MEMORANDUM

SUBJECT: Dewatering for the Planned Rosemont Mine
(FS MPO Comments – Item Nos. 1 and 4 [GW-1 and GW-3])

AUGUSTA RESOURCES / ROSEMONT
FIGURE 1

**PRIMARY DEWATERING
AREAS**

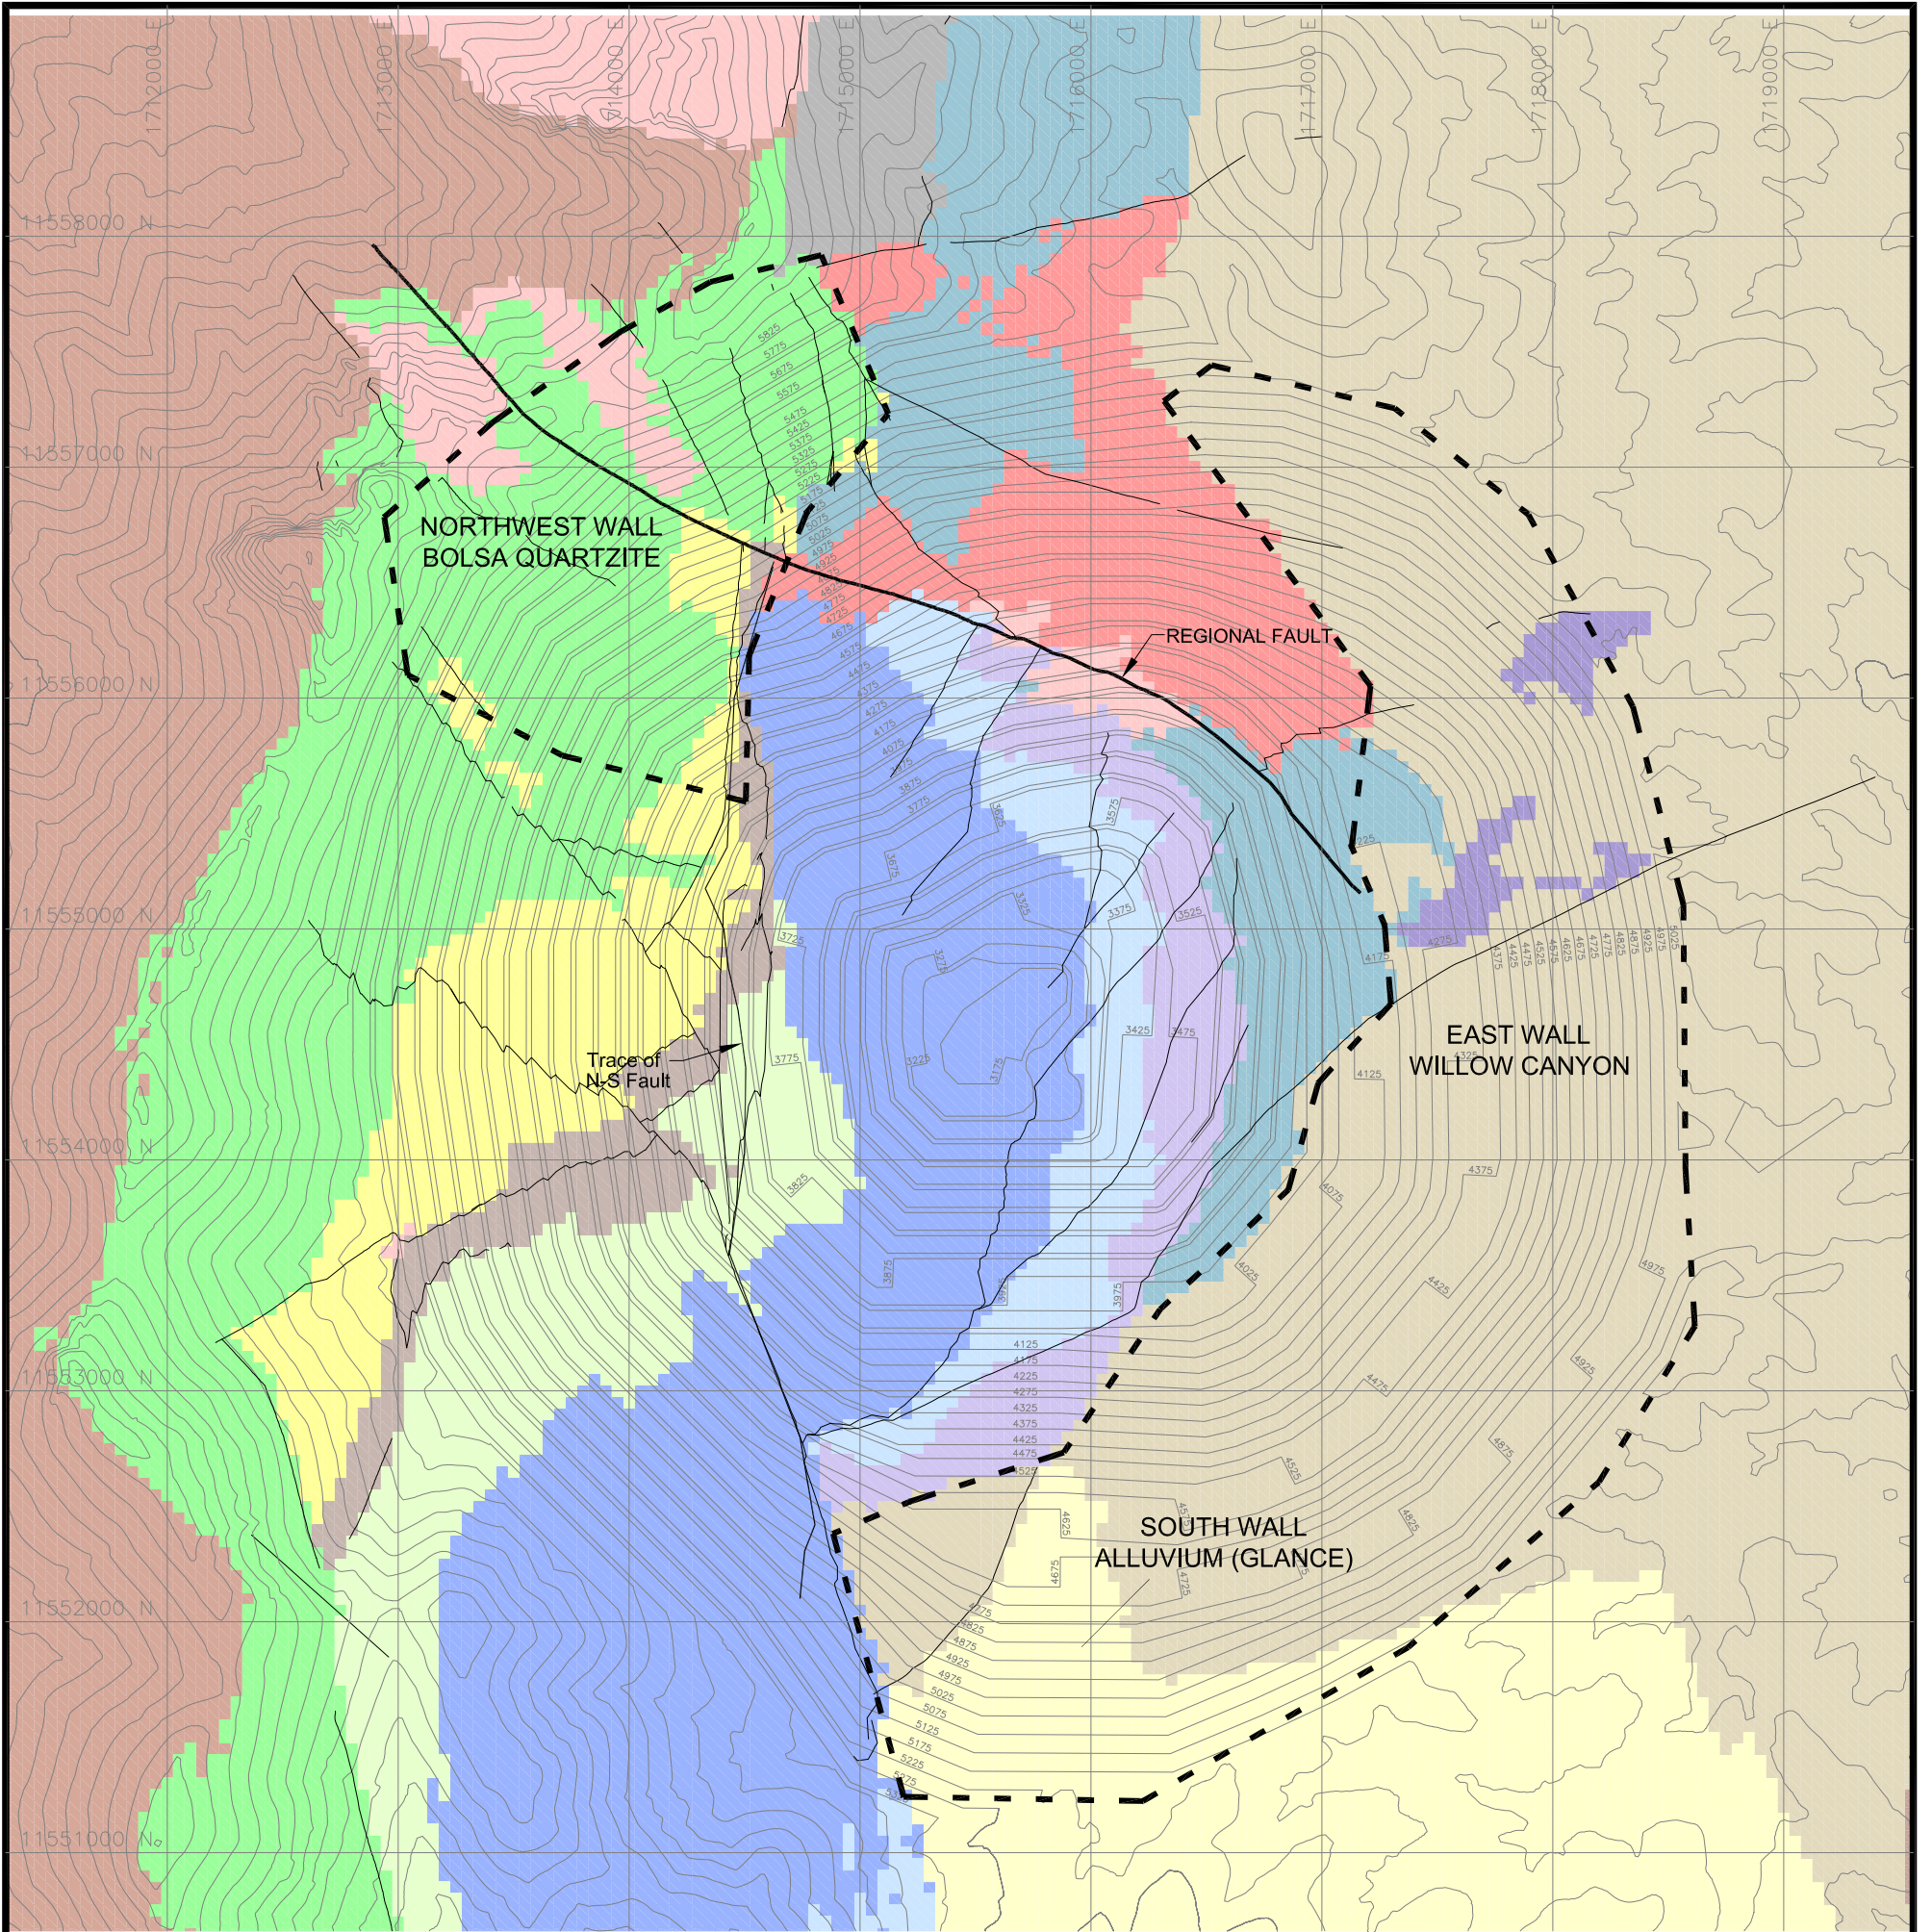
Based on the results of slope stability analyses done by CNI, depressurization by dewatering will primarily be required in (1) the east wall Willow Canyon Formation, (2) the south wall alluvial conglomerate, and (3) the northwest wall Bolsa Quartzite. These areas are shown on Figure 1.
